**Fingerboards Mineral Sands Project Inquiry and Advisory Committee
Technical note**

TN No: TN 004

Subject: Response to IAC Request for Information – Part 2.8, questions 23 and 24

Figure 1: Sensitive receptors within 2km of the Project

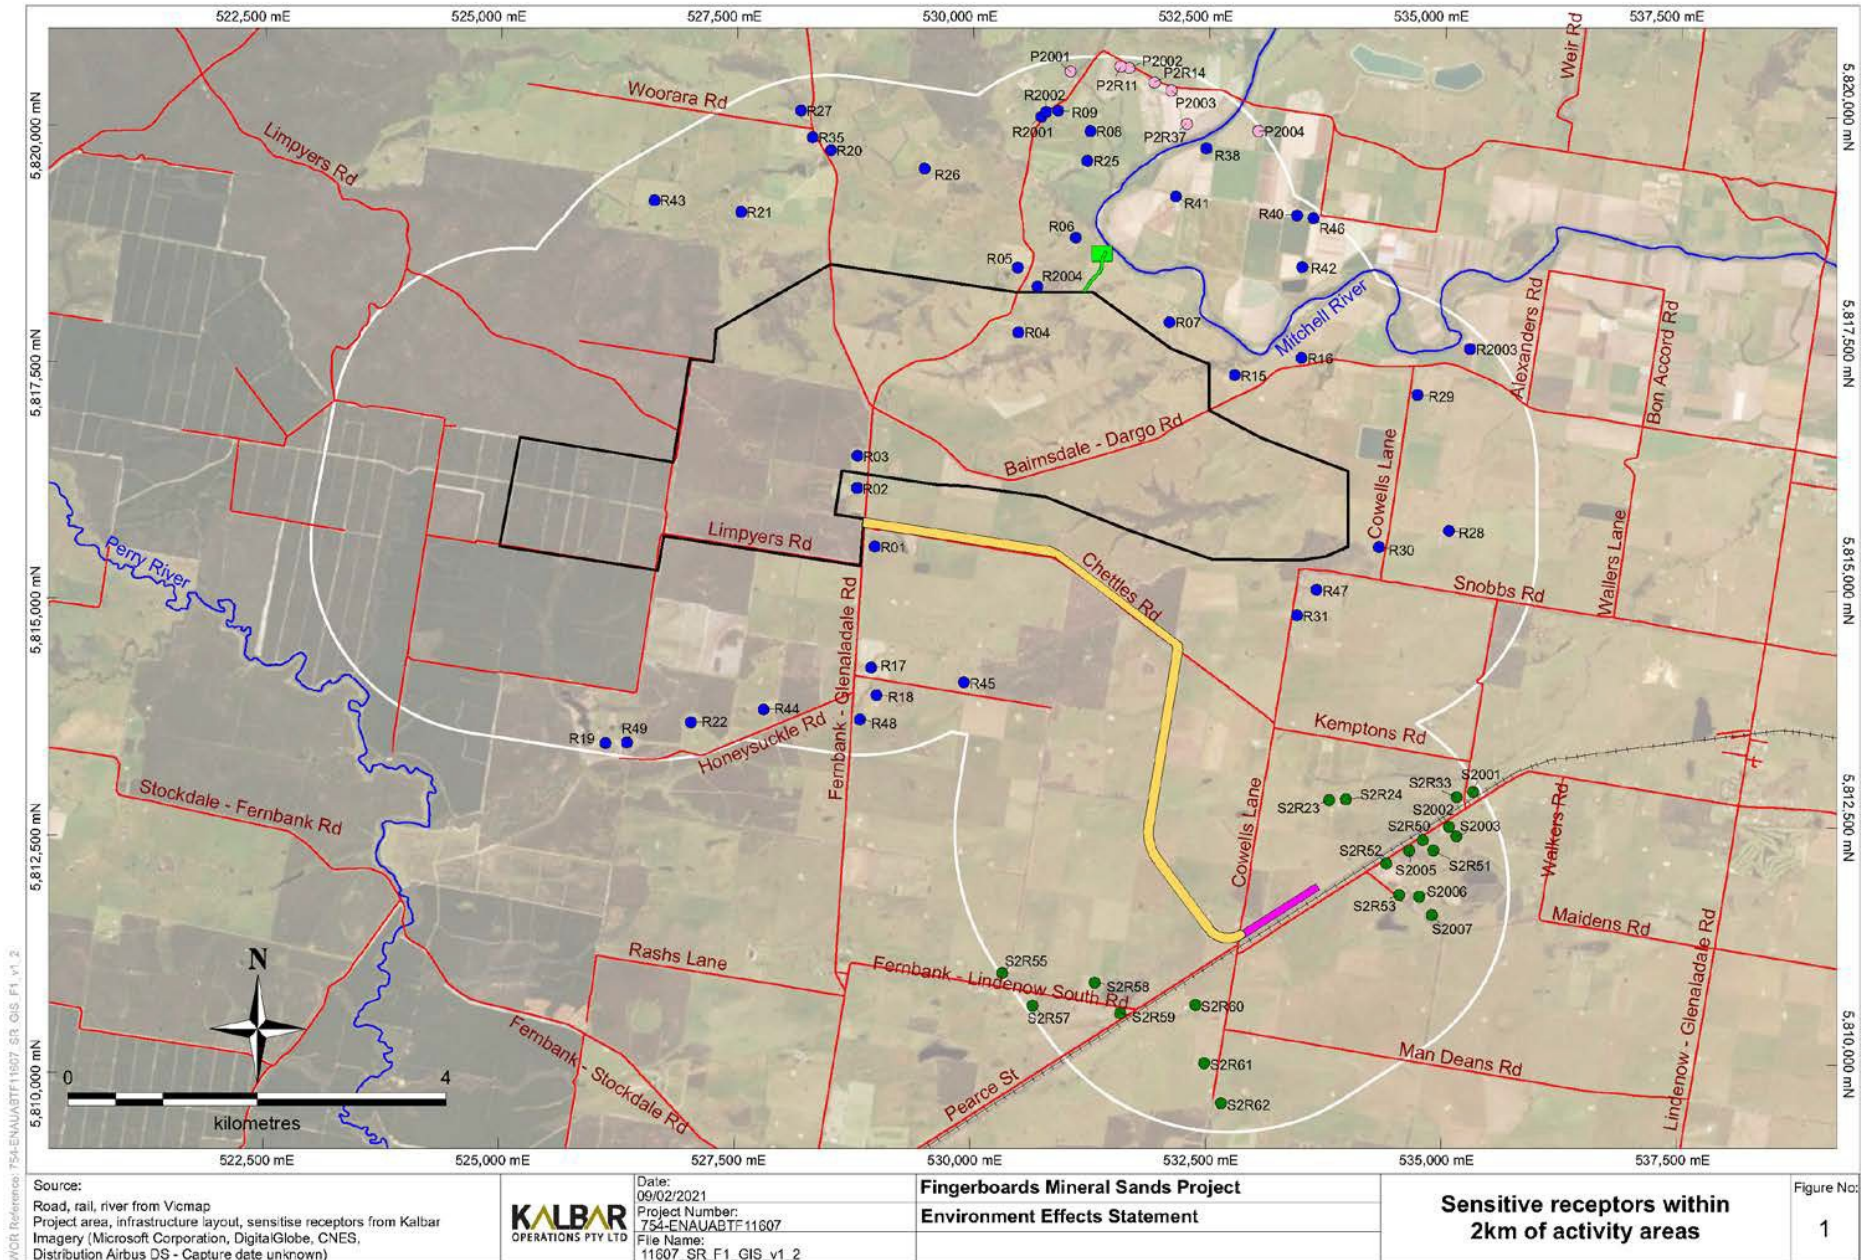
23. Clarify the number and type of sensitive receptors that are within: (a) 2kms; and (b) 5kms of the Project boundary, including the proposed haul road and proposed Fernbank rail siding footprint.
24. To the extent that additional sensitive receptors are identified that were not included in the EES, provide updated impact assessments on the following issues for each of these receptors:
 - a. Air quality
 - b. Noise and vibration
 - c. Traffic and transport
 - d. Landscape and visual
 - e. Agricultural and horticultural (as relevant)
 - f. Socioeconomic
 - g. Human health risk.

Table 1 and Figure 1 below show receptors that are within 2km of the Project boundary (including the Project Area, proposed haul road, Fernbank East rail siding and Mitchell River Pump Station). The

receptors identified with a blue dot on Figure 1 are within 2km of the Project Area whereas receptors identified with a pink or green dot on Figure 1 are within 2km of only the haul road, rail siding or pump station.

- disclosed two further residences (R2003 & R2004) and removed one (R36 - demolished) within 2km of the Project Area
- includes Glenaladale CFA (R2001) and Glenaladale Recreation Reserve and Hall (R2002) as receptors
- excludes receptors within the vicinity of East Gippsland Water’s Glenaladale pump station option, which is no longer being pursued by Kalbar
- includes receptors within 2km of the Mitchell River Pump Station and in doing so, has included four further residences (P2001, P2002, P2003, P2004)
- includes receptors within 2km of the haul road and rail siding and in doing so, has included six further residences (S2001, S2002, S2003, S2005, S2006, S2007)

Figure 1 below depicts the location of the sensitive receptors identified in Table 1. Receptor prefixes provided on Figure 1 are:

- R – within 2km of project area
- S – within 2km of proposed haul road and Fernbank East rail siding
- P – within 2km of Mitchell River pump station

Figure 1: Revised receptor location map provided by Kalbar 9 February 2021 – additional receptors circled

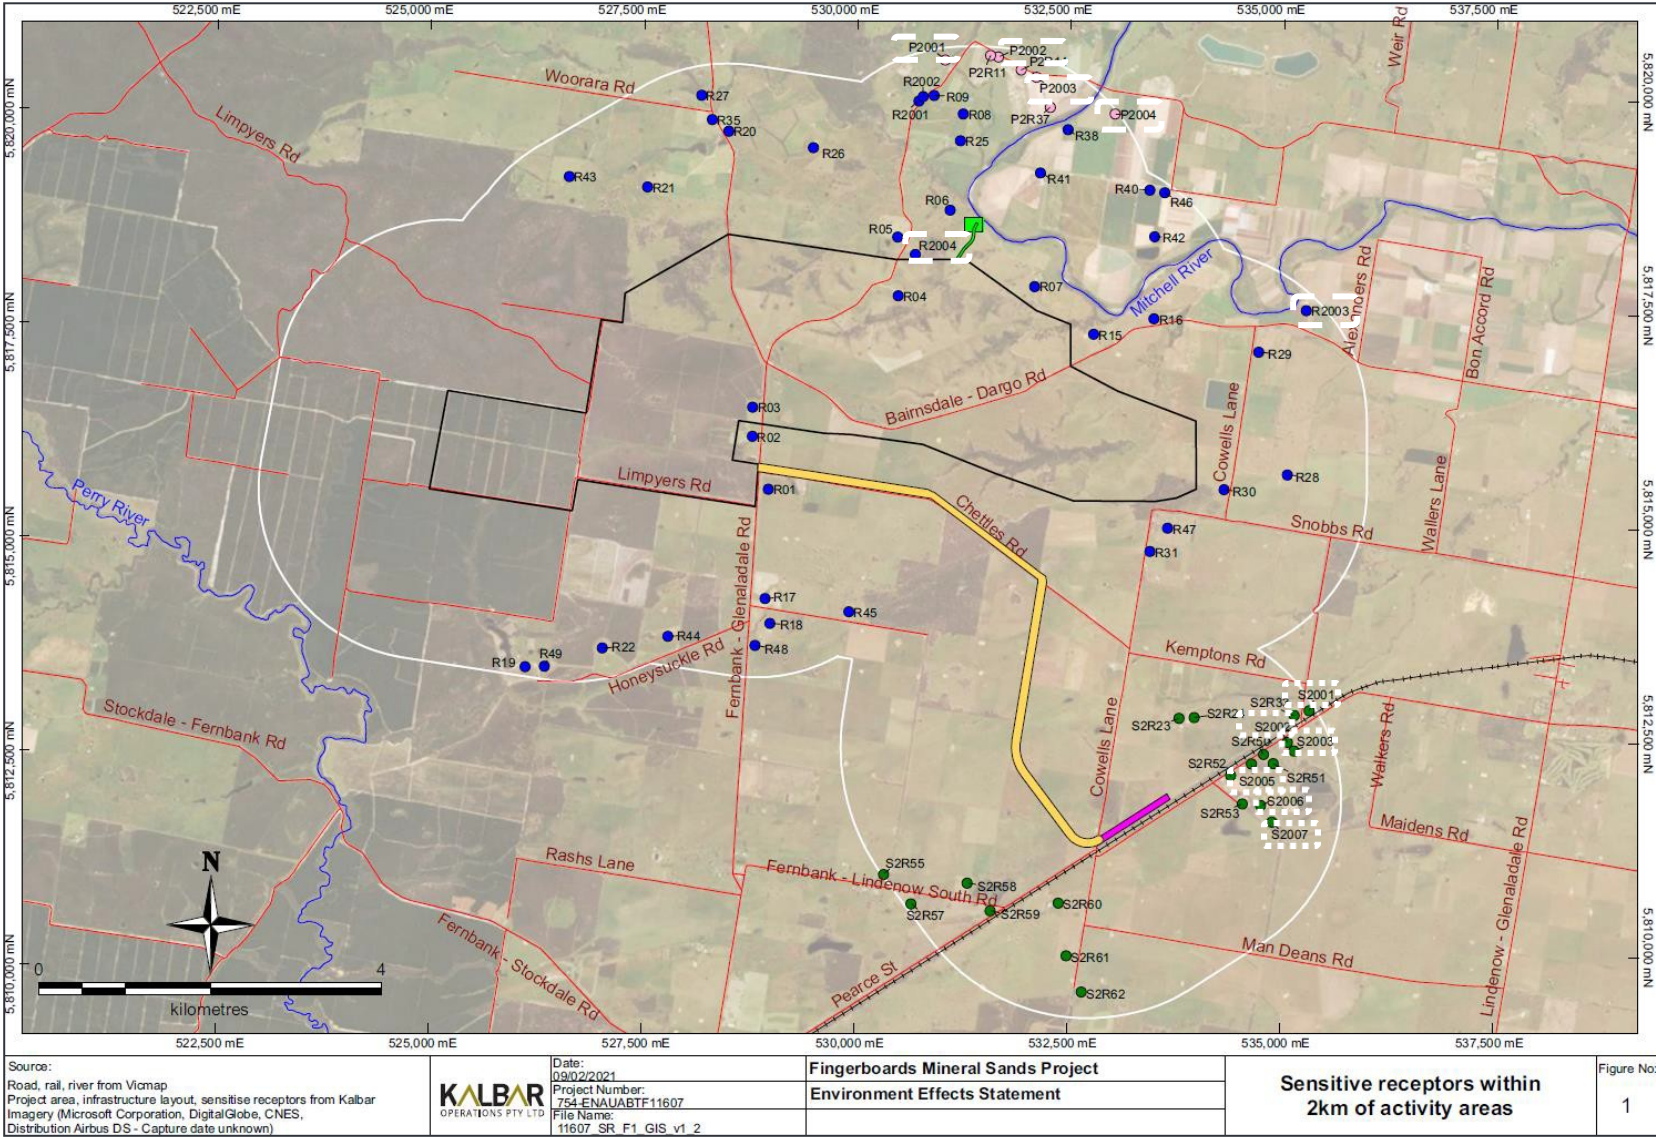
Kalbar has identified a number of additional sensitive receptor locations in the vicinity of the Project.

A revised sensitive receptor map provided by Kalbar is reproduced in Appendix A.

The one additional receptor location that is nearer to the Project is receptor R2004, located adjacent to the northern boundary of the Project. R2004 is located approximately 280 m to the southeast receptor R5 which was the nearest receptor to the northern boundary of the Project considered in the MDA report and my evidence statement.

While receptor R2004 is closer to the Project boundary than receptor R5, operational noise levels are predicted to be comparable to those of receptor R5, on account of the location and arrangement of noise sources around the Project site. This is evident from the predicted noise contour maps presented in Appendix H of the MDA report Rp 001 R12 20170182 which indicates noise levels may be slightly lower or higher than at the location of receptor R5, depending on the year of operation. Importantly, the location of receptor R2004 on the noise contour maps is well outside the noise contour lines which correspond the NIRV recommended levels for the day, evening and night. Predicted noise levels at receptor R2004 would therefore be well below the NIRV recommended levels for all scenarios and time periods.
